**MURPHY
SERVICE
INSTRUCTIONS**

Circuit Analysis

Modifications

Production Changes

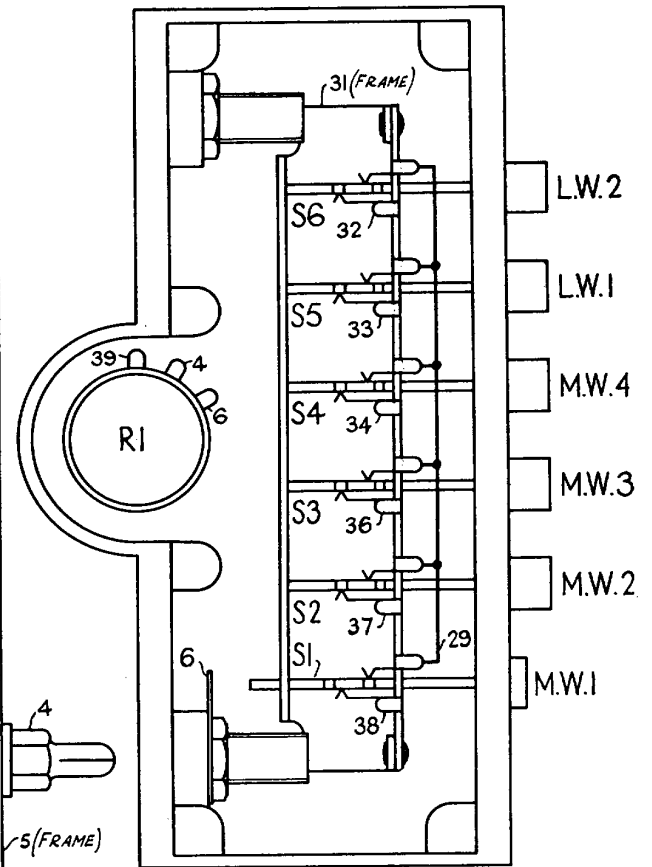
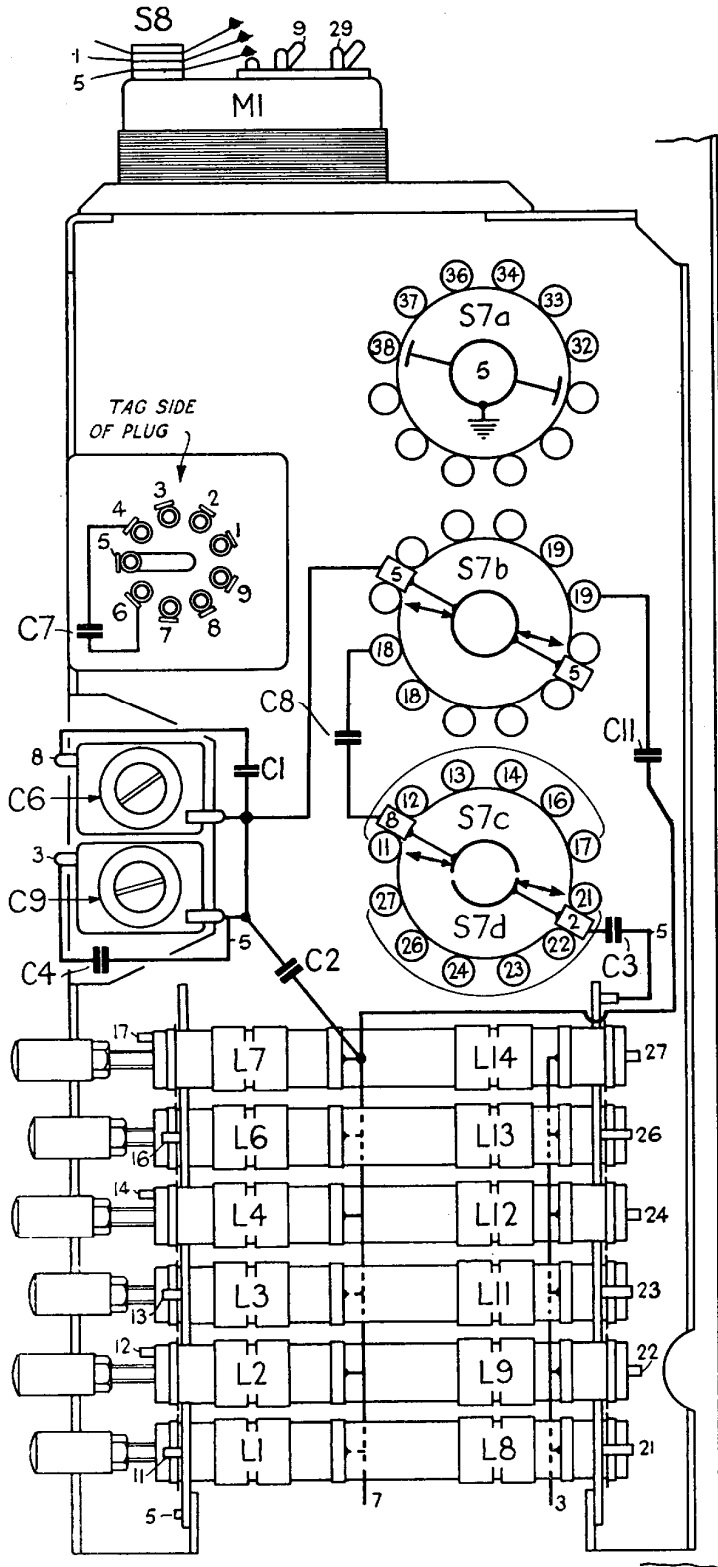
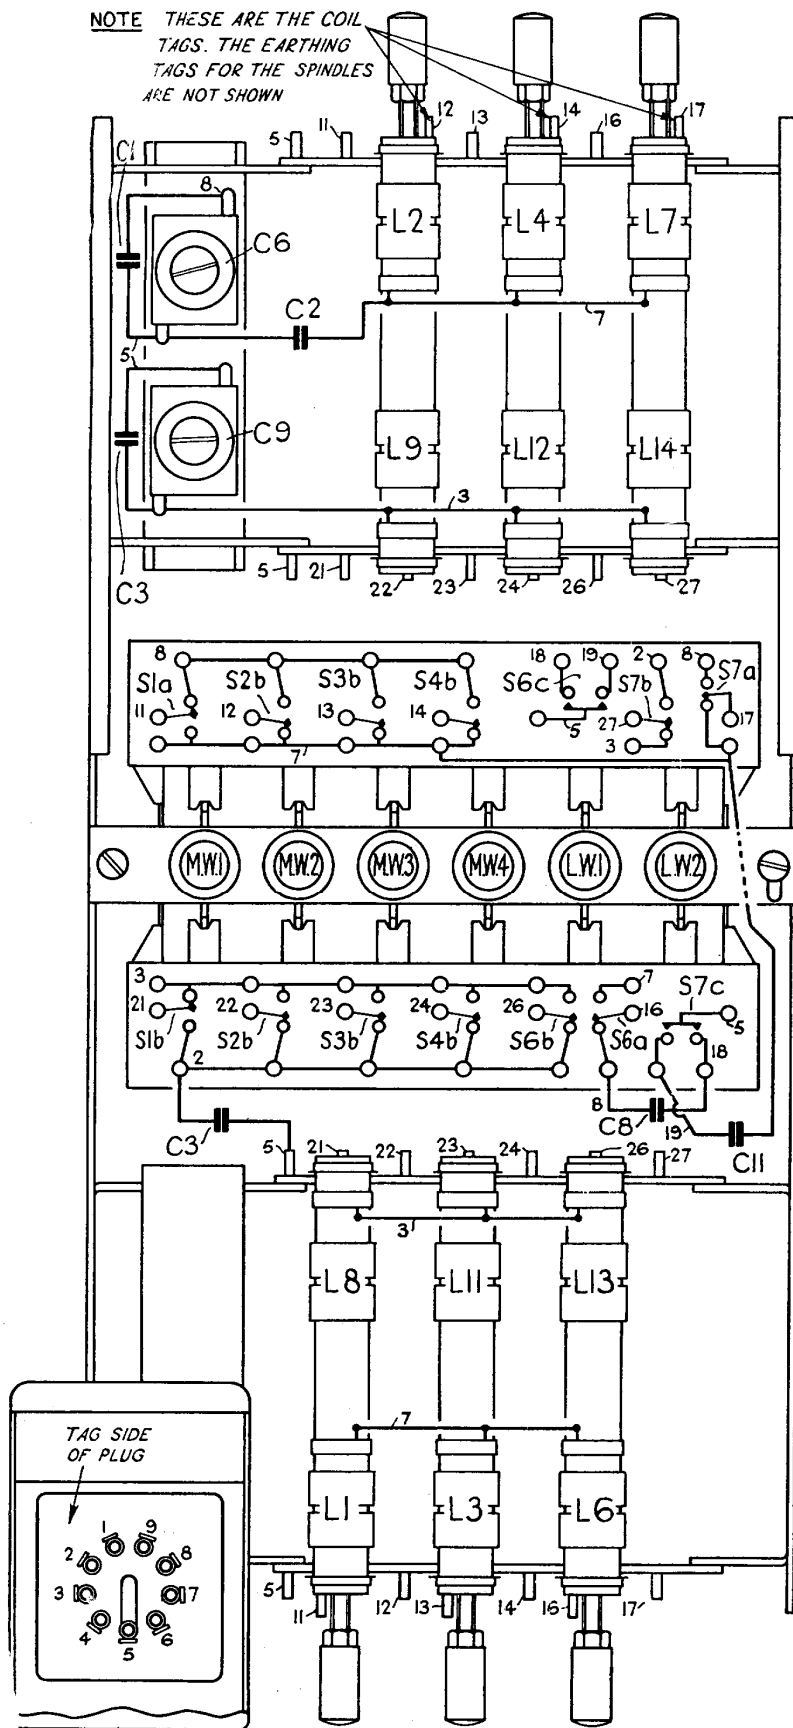
The R80 Remote Control Unit. The drawing on the next page shows a plan of the modified RA80 coil, switch, and motor assembly, with the switches "flattened," and one or two components moved slightly to show the connecting tags. To make an early type unit to conform to this arrangement the following modifications are needed.

1. Disconnect the common lead for the grid coils (L1 to L7) from the chassis tag.

2. Disconnect the white tracer wire from the common tag of S7b and connect it to the common lead for the grid coils (L1 to L7). This line will now be connected by the white tracer wire to tag 7 on the connector plug, instead of being connected to chassis as it was originally.

3. Remove C2 and connect a link of wire in its place. This will connect the common tag of S7b and one side of C1 and C6 to chassis (5).

4. Connect a 60 p.f. condenser (to replace C2) between the common grid coil line (7) and the chassis tag (5) on C6.

5. Replace C11 with a condenser of 420 p.f. and connect it between the switch and the common lead for the grid coils (7) instead of between the switch and chassis as it was originally.

The P80 Press Button Unit. The drawing of the P80 shows the unit looking from the press button end with the two sides "flat-

As in the case of the RA80, the modified unit has been drawn and the modifications necessary to make an early type unit conform to this are as follows:

1. Disconnect the common lead for the grid coils (L1 to L7) from the chassis tag (5).

2. Disconnect the yellow tracer wire from the end tag of S7C, shorten it, and connect it to the common grid coil lead. This lead is thus connected to tag 7 on the connecting plug instead of to chassis (5) as previously.

3. Disconnect the wires connecting S7a and S6a to chassis (5) and join them together. Actually the systoflex covered lead from S6a should reach to the top tag on S7a, and the short bare wire from S7a can be cut away.

4. Replace C11 with a condenser of 360 p.f. and connect it between S7C (1a) and the common lead for the grid coils (7) instead of between S7C and the chassis, as it was originally.

5. Connect a yellow tracer wire from the common grid coil line (7) to the top tag on S6a.

6. Connect a wire between the chassis tag (5) on the "adjustment" end of the coil assembly, to the junction of C2 and C6.

7. Replace C2 with a 60 p.f. condenser.

denser (C6) may require readjustment. If the oscillator pre-set condenser is not touched a sufficiently accurate adjustment can be made by tuning-in a M.W. station on press-buttons, and adjusting the condenser C6 for maximum output. This must be done with
